23 December 2021

**Re: 84 MANOR ROAD
HOMEBASE MANOR ROAD
PUBLIC CONSULTATION ON AMENDED APPLICATION
LOCAL AUTHORITY REF: 19/0510/FUL / GLA REF: 4795**

Image 5 – relocated car parking spaces and consequential loss of landscaping

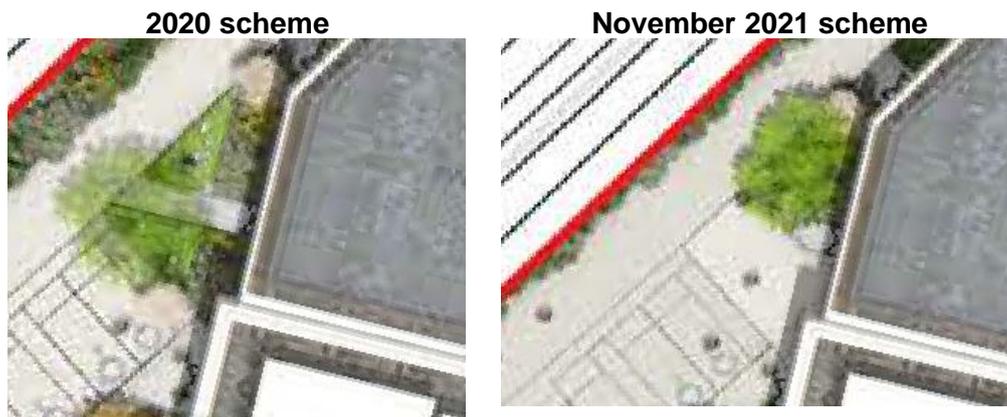
The changes to the boundary line and subsequent relocation of parking bays, results in loss of pockets of landscaping and relocation of play areas (Image 5), however, it is unclear if there is a corresponding loss of tree planting. The above conditions are thereby recommended to ensure suitably mitigation planting is secured, in addition to the following

- Public Realm to accord with the Public London Charter (Policy D8 of the London Plan)
- Provision of water fountains within the public realm (Policy D8 of the London Plan)

Image 7: Green roof comparisons

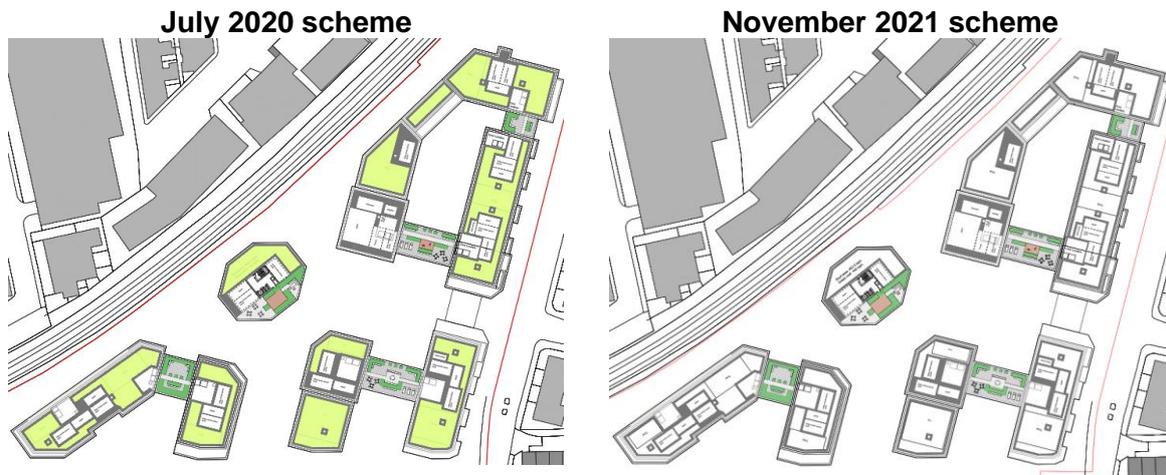
Green roof: Policy G1 and G5 of the London Plan seeks green infrastructure to be incorporated within the development recognising urban greening as a fundamental element of a site and building design, with major developments needing to incorporate measures such as green roofs, green walls etc. Local Plan policy LP17 is more prescriptive, requiring at least 70% of any potential roof plate areas as a green / brown roof. The 2021 scheme roof plan shows a significant reduction in biodiverse roof covering (righthand of Image 7) compared to that of the 2020 scheme (left hand image), which also contradicts the drawings presented in the Urban Greening Factor drawing. The Council thereby requests the GLA explore such inconsistency and ensure maximum coverage is proposed, in line with policy, which is secured via condition.

Image 9: Location of the additional disabled persons parking bays in green

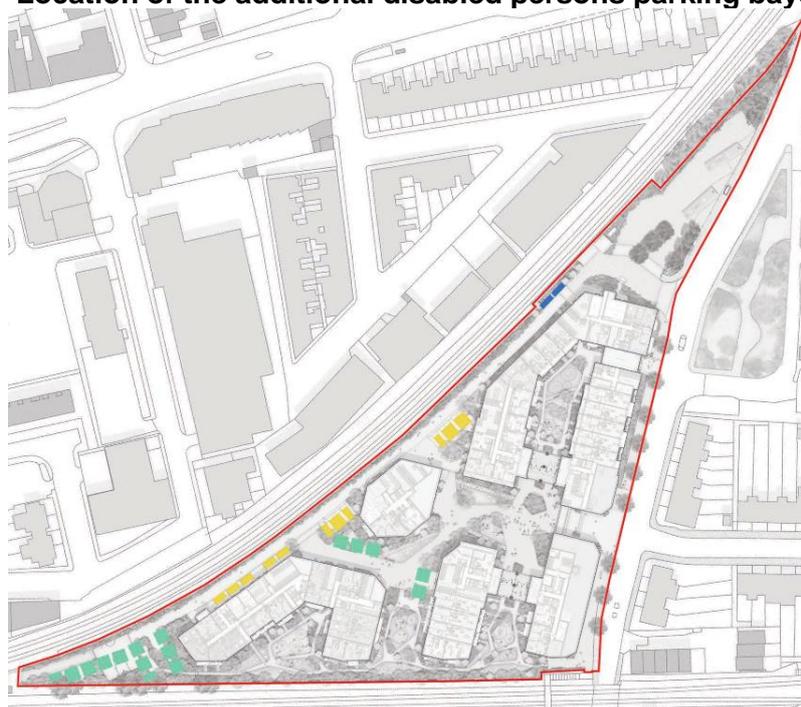
The Council also objected to the location of the additional provision (7% of dwellings), which equates to 30 spaces, whereby these resulted in an unacceptable loss of amenity space, playspace, landscaping and short-term cycle parking, again, reflecting overdevelopment of the site, as illustrated in Image 9. The 2021 scheme fails to address previous concerns. In light of the revised boundary changes and the consequential relocation of car club bays and parking space and loss of landscaping, the previous objections are even more pertinent.

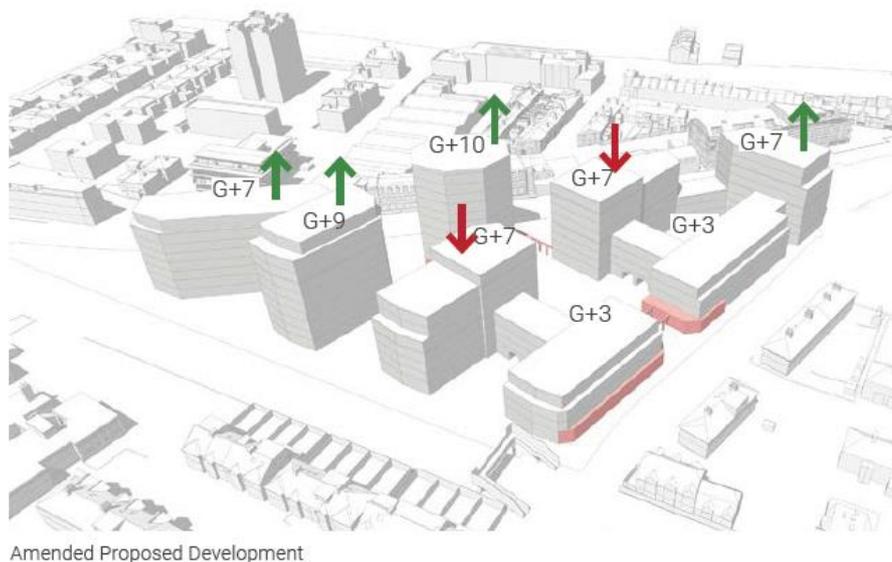
3.3 The reductions in height to Blocks A and D adjacent to the public square are supported and lessen the impact of the development in views along Manor Road. However, the Council refused the scheme largely based on the disjuncture of height with the surrounding context (and within the development site itself), and this objection strongly remains. It is noted that the Draft London Plan requires Council’s to consider carefully the heights of new development against context and to ensure that detailed work is
